Title of Change:	Lead Frame Design change for PDIP7 Products Assembled in Advanced Semiconductor Engineering (ASE) Kunshan, China.
Proposed first ship date:	18 August 2017 or earlier after customer approval.
Contact information:	Contact your local ON Semiconductor Sales Office or <marty.paul@onsemi.com>
Samples:	Contact your local ON Semiconductor Sales Office
Additional Reliability Data:	Contact your local ON Semiconductor Sales Office or <Andy.Esteva@onsemi.com>
Type of notification:	This is a Final Product/Process Change Notification (FPCN) sent to customers. FPCNs are issued 90 days prior to implementation of the change. ON Semiconductor will consider this change accepted, unless an inquiry is made in writing within 30 days of delivery of this notice. To do so, contact <PCN.Support@onsemi.com>.
Change Part Identification:	Affected products will be identified with date code 1733 or newer. After DC 1733, customers will receive products assembled with either lead frame design.

This FPCN is to notify customers that qualification has been completed for a new Lead Frame form on PDIP7 packages assembled at the ASE, Kunshan, China assembly location for the products listed in this anno

Figure 1 - External End View

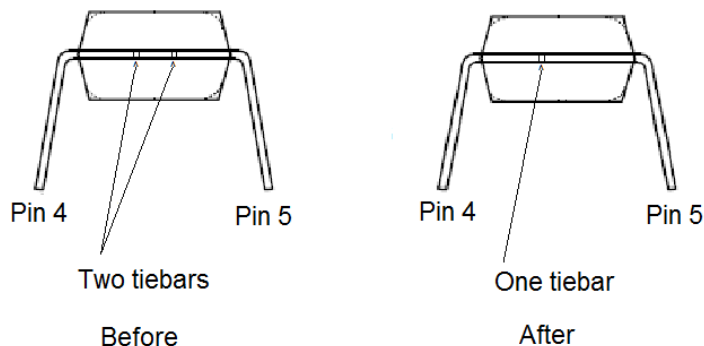
The form of the Lead Frame has been modified to improve creepage distance between tie bars, see figure 1. One tie bar has been removed.

Material to be changed	Before Change	After Change
	Description	Description
Leadframe	PDIP7 Lead frame with 4 tie bars	PDIP7 Lead frame with 3 tie bars
